# Legislative Council Environment and Planning Committee

**Question taken on notice**

### **Flemington Floodwall modelling by GHD**

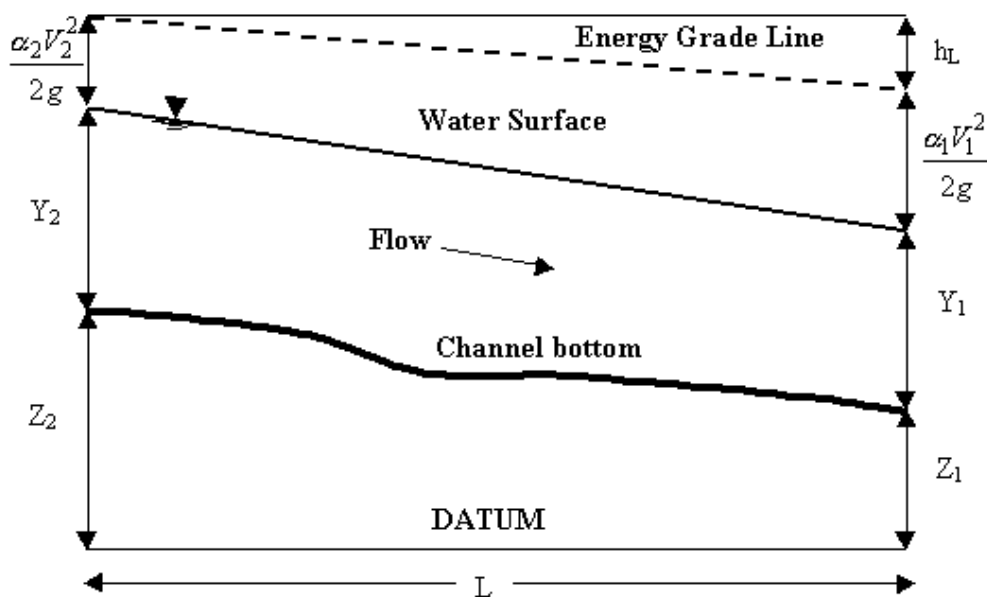
## Conclusion

A number of shortcomings were identified that has led to the conclusion that the impacts presented in the report cannot be considered reliable until these issues are addressed. They are summarised below.

- Sensitivity testing and/or further rigorous analysis is required to demonstrate the significance of the assumed stage-storage relationship.
- Flood level impacts downstream of Lynchs Bridge may need to be reviewed subject to the outcomes of the above sensitivity test.
- The assessment of impacts in the Fisher Road to Lynchs Bridge reach may be underestimated because of the location of the downstream boundary and the assumed water level at the boundary. The report should also provide comment on the affect of adopting a steady state model on flood level impacts.
- The reduction in the expansion loss coefficient at the Footscray Bridge may be too large given that the training wall is not being constructed at both abutments.
- The afflux should be presented as change in water level as well as change in TEL for all cases assessed.

A complicated methodology combining HEC-RAS, FLS and RORB was required to assess the impacts of the proposed floodwalls because neither HEC-RAS nor FLS could adequately model the system in its entirety for the purposes of this study. Hydraulic modelling software is available (and has been for some years) that could model the system within one package by utilising dynamic links between one-dimensional and two-dimensional domains. The use of such software would have eliminated the first three concerns raised above.
